**Re: Initial Submission Review – Kings Point North West – Site Plan (ISP)**  
Application Number: **DA-1609-20**  
Case Numbers: **2021-6058-00**

## *Initial Submission Review*

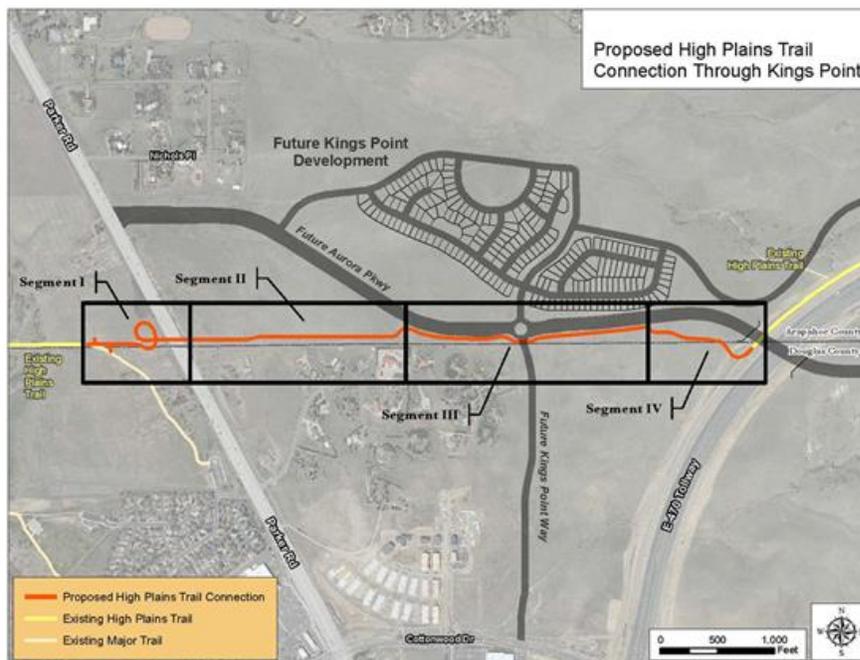
The proposal to construct a soft surface or crusher fines trail is not supported by the Partners. The High Plains Trail Partners request that COA require the entire High Plains Trail, Segment III (refer to the below graphic), be constructed as a hard surface as per the horizontal and vertical alignment for the sidewalk shown in the Kings Point North - West Infrastructure Site Plan. This is a regional trail serving thousands of users. The connection east on Segment III is essential for the residents to the north and northeast to

access the Cherry Creek Trail. A soft surface trail is an unsuitable surface for road bikes with thin tires and roller blades. Also, it is unknown when the eastern portion of Aurora Parkway and bridge over E-470 will be constructed; this “Temporary” trail segment east of the roundabout could be in place for many years.

Arapahoe County and City of Parker formally request a concrete trail be constructed for the entire trail in Segment III in the final alignment, as shown below. Construction of the entire concrete trail in segment III, in final location and alignment will avoid future conflicts, closures and detour requirements when this section of Aurora Pky. is built. If a temporary trail is built, in the future the entire area will need to be closed for months for grading and construction and a detour will be needed.
